Hornsea Project Three
Offshore Wind Farm

Appendix 20 to Deadline I Submission –
Main Construction Compound Briefing Note

Date: 7th November 2018

APPENDIX B – Problem Location Plan

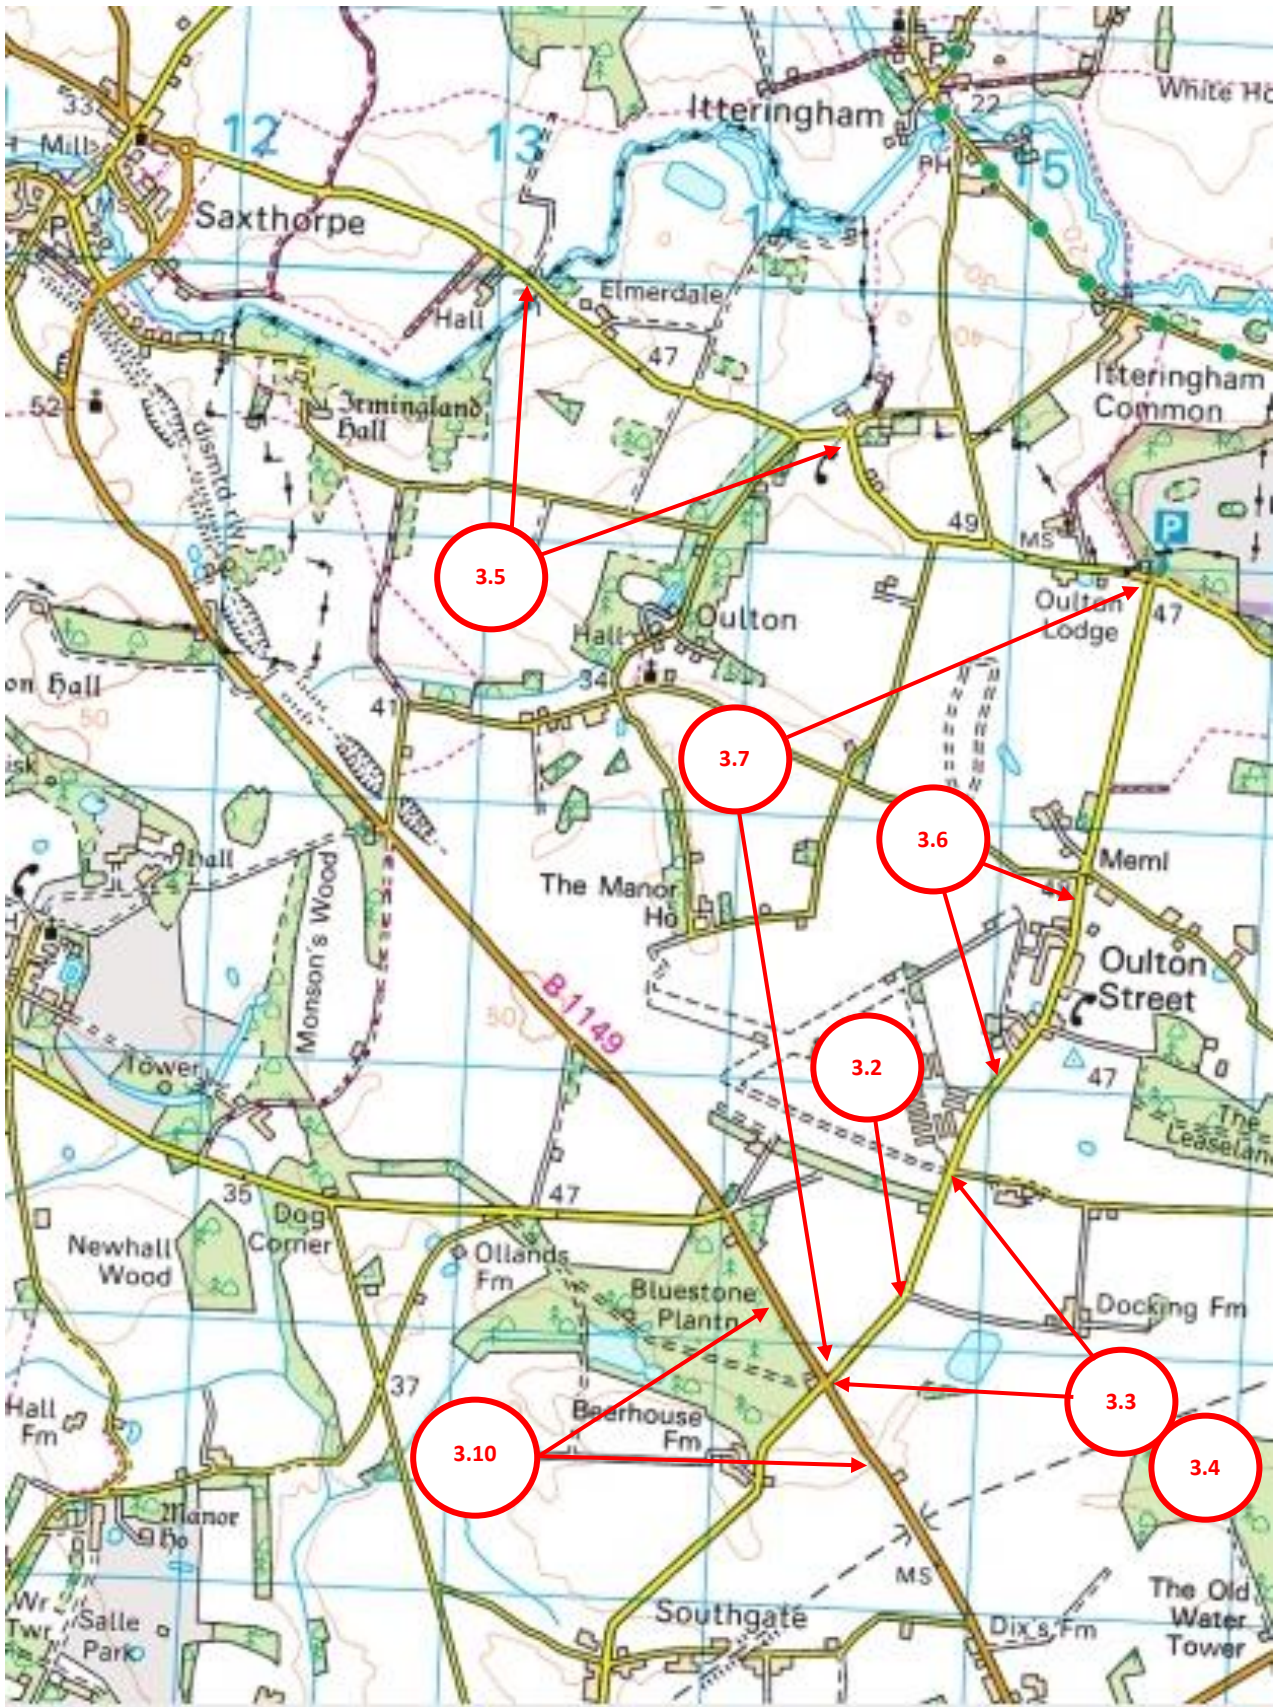
Comment	Affected Options					Comments
	1	2	3a	3b	Location	
3.1				✓	The Street	<p><u>Problem:</u> head-on collisions due to a 12km one-way system that could be contravened by local users/residents of The Street to avoid a lengthy diversion.</p> <p><u>Recommendation:</u> Re-assess the principle of the proposed one-way system.</p>
3.2	✓	✓	✓		Bend in The Street	<p><u>Problem:</u> head-on collision on bend due to restricted forward visibility at the bend in The Street.</p> <p><u>Recommendation:</u> Widen the carriageway on the outside of the bend to reduce the likelihood of conflict. The Auditors note that there is a wide bellmouth on the outside of the bend. It appears that providing an edge of carriageway marking a metre or two back into the bellmouth might achieve much of the desired widening.</p>

3.5			✓	✓	Blickling Road	<p><u>Problem:</u> Blickling Road is particularly narrow and twisty between Itteringham Road and The Bure bridge, with limited forward visibility and may be unsuitable for large articulated HGV, which may lead on head-on collision.</p> <p><u>Recommendation:</u> Re-assess in detail the suitability of this route for use by large HGVs.</p>

Comment Ref.	Agree/Disagree	Reasons/Proposals
3.1	Agree	Option 3b is no longer pursued
3.2	Agree	Carriageway is to be widened by edge of carriageway marking a metre or two back into the bellmouth.
3.3	Agree	Option 2 is no longer pursued
3.4	Agree	Option 2 is no longer pursued
3.5	Agree	Options 3a and 3b are no longer pursued.
3.6	Agree	Options 3a and 3b are no longer pursued.
3.7	Agree	Option 3b is no longer pursued
3.10	Agree	Signing is to be proposed as part of the access design layout. A red background sign stating 'CAUTION HGVs TURNING' is to be provided on the B1149 near the junction (or similar signing to be agree with the Highway Authority).

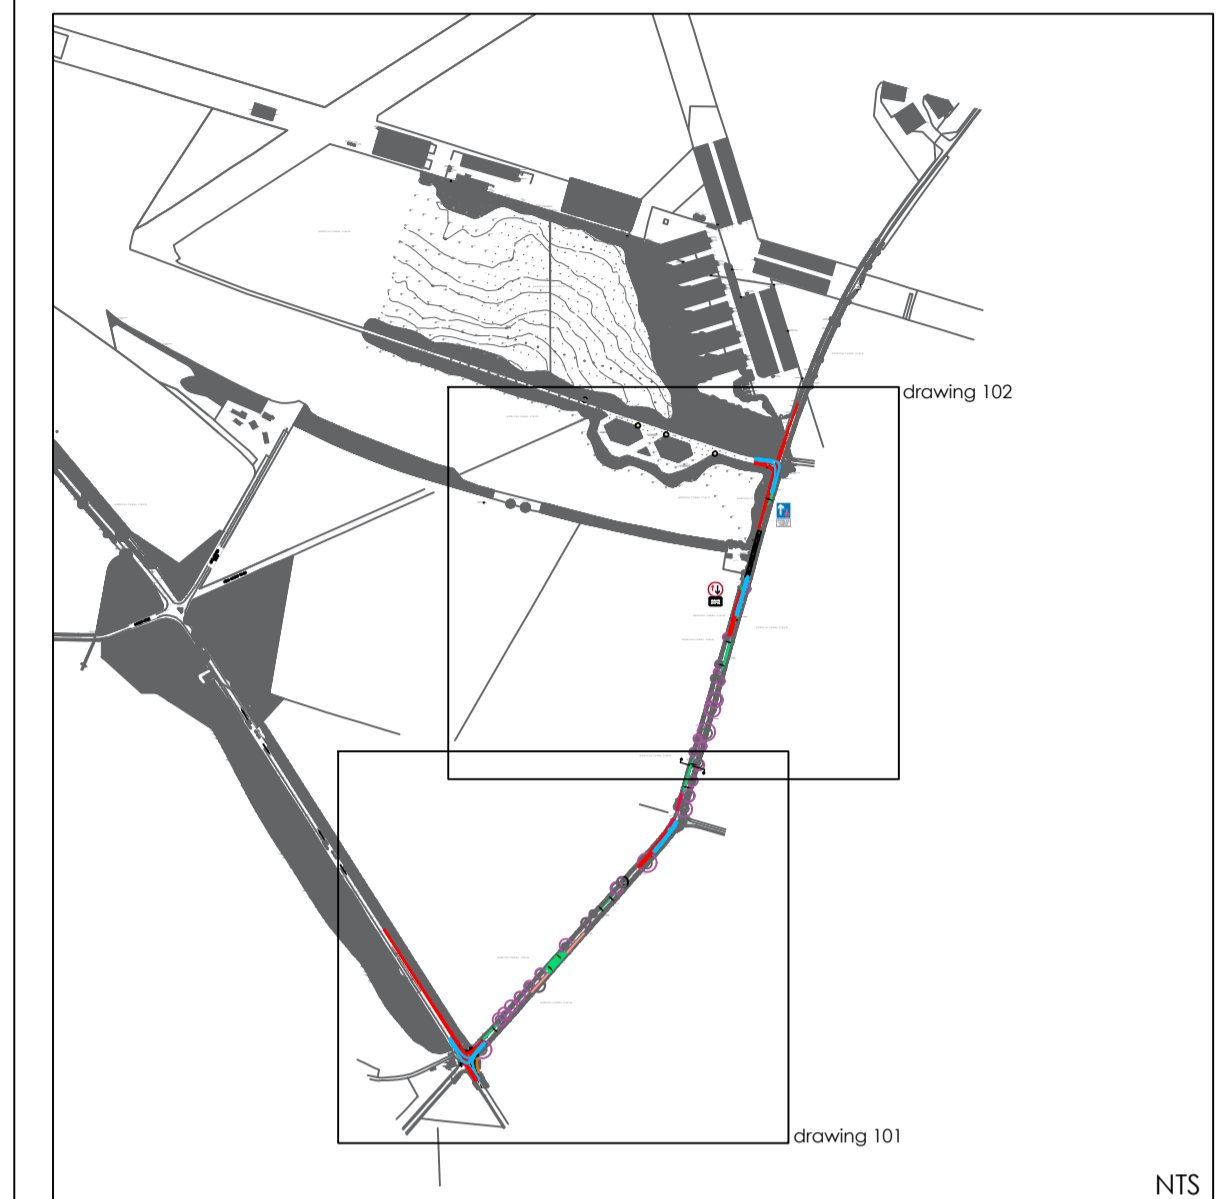
Recommendation

Specific advance signing is suggested to warn drivers of the potential for conflict with slow turning HGVs.

Engineer's Response:

2.22 Agree. Signing is to be proposed as part of the access design layout. A red background sign stating 'CAUTION HGVs TURNING' is to be provided on the B1149 near the junction (or similar signing to be agreed with the Highway Authority).

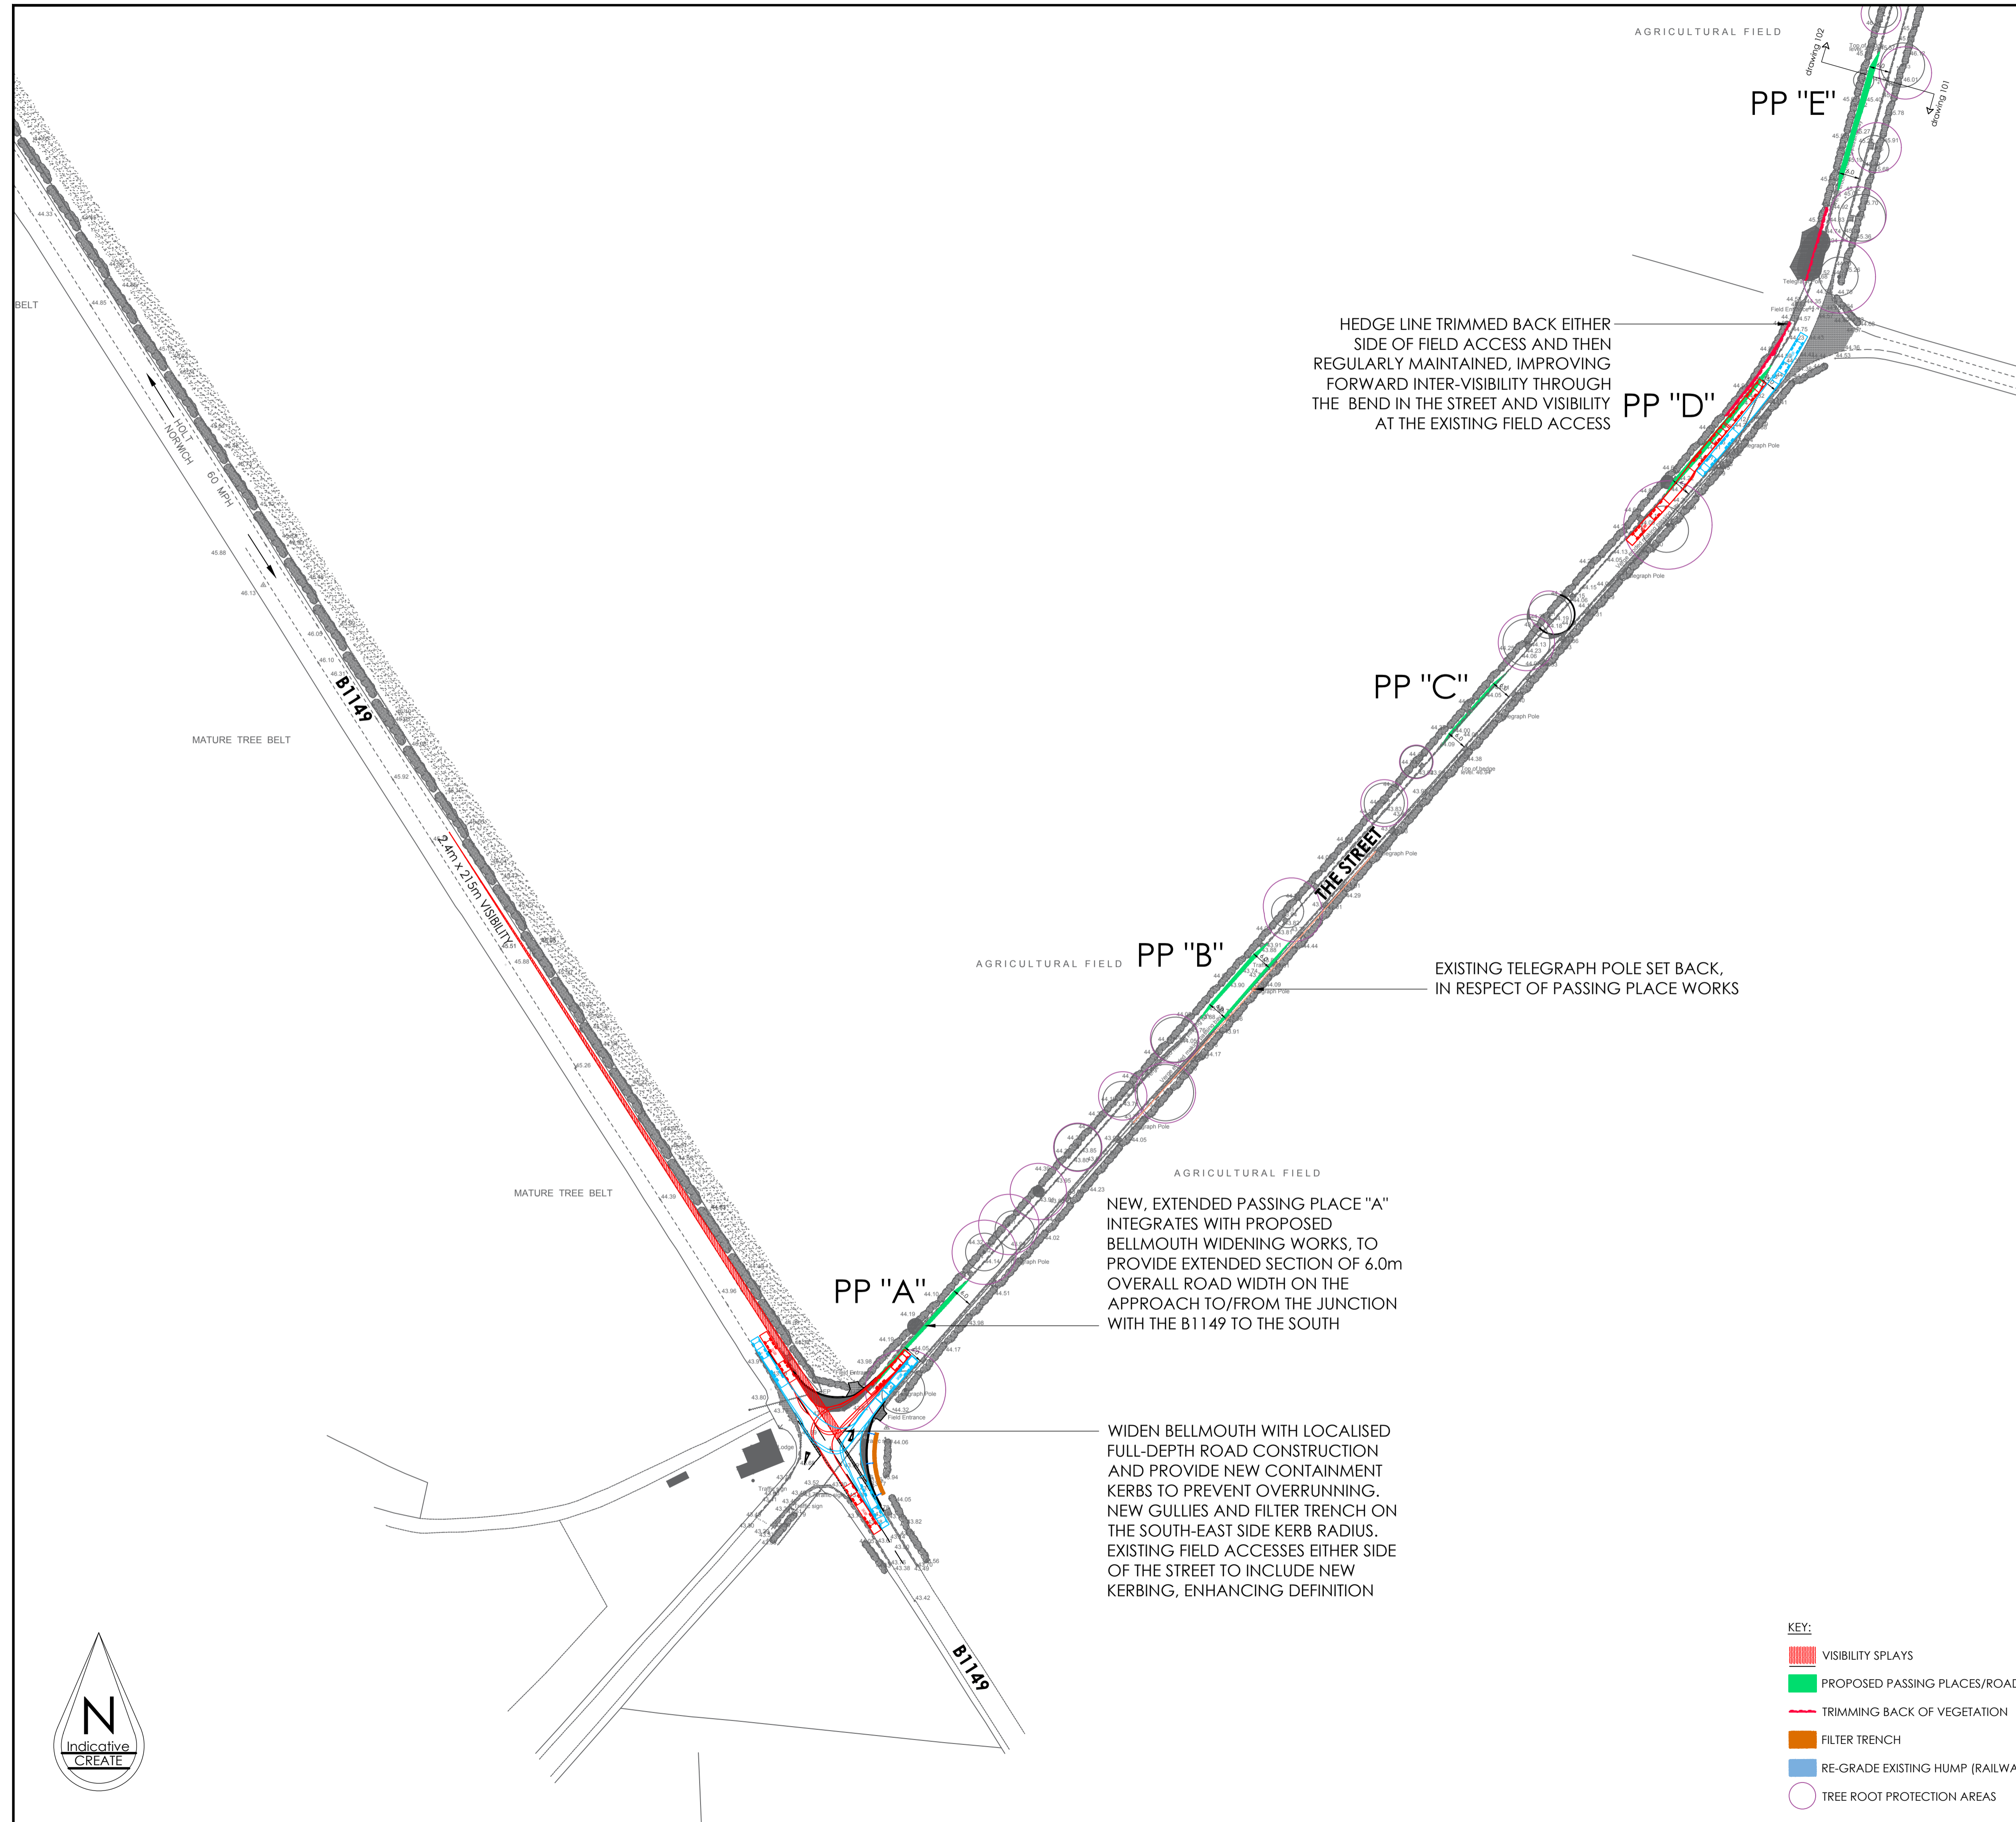
2.5 Ref 3.2: Approx. 400m north-east of B1149 there is a bend in The Street with restricted forward visibility. It is proposed to improve visibility by hedge trimming, however the Auditors estimate that it will still be substandard, raising the risk of head-on collision on the narrow carriageway, particularly between larger vehicles. This comment affects options 1, 2 and 3a.

- 4.3 Taking account of the Safety Audit and designer's response Option 1 as shown on Create Drawings number 1554_03_101 and 1554_03_102 contained in Appendix C is recommended for approval by Norfolk County Council.
- 4.4 It has been agreed with Norfolk County Council that a final scheme design will be prepared and submitted prior to Deadline 2 which will also include the following;
- Scheme to be updated to include safety audit comments; and
 - Pavement Assessment of The Street;
 - Construction details of the passing bays with confirmed axle loading; and
 - Construction design of the vertical alignment changes adjacent to the Old Railway Gatehouse.

HEDGE LINE TRIMMED BACK EITHER SIDE OF FIELD ACCESS AND THEN REGULARLY MAINTAINED, IMPROVING FORWARD INTER-VISIBILITY THROUGH THE BEND IN THE STREET AND VISIBILITY AT THE EXISTING FIELD ACCESS

NEW, EXTENDED PASSING PLACE "A" INTEGRATES WITH PROPOSED BELLMOUTH WIDENING WORKS, TO PROVIDE EXTENDED SECTION OF 6.0m OVERALL ROAD WIDTH ON THE APPROACH TO/FROM THE JUNCTION WITH THE B1149 TO THE SOUTH

WIDEN BELLMOUTH WITH LOCALISED FULL-DEPTH ROAD CONSTRUCTION AND PROVIDE NEW CONTAINMENT KERBS TO PREVENT OVERRUNNING. NEW GULLIES AND FILTER TRENCH ON THE SOUTH-EAST SIDE KERB RADIUS. EXISTING FIELD ACCESSES EITHER SIDE OF THE STREET TO INCLUDE NEW KERBING, ENHANCING DEFINITION
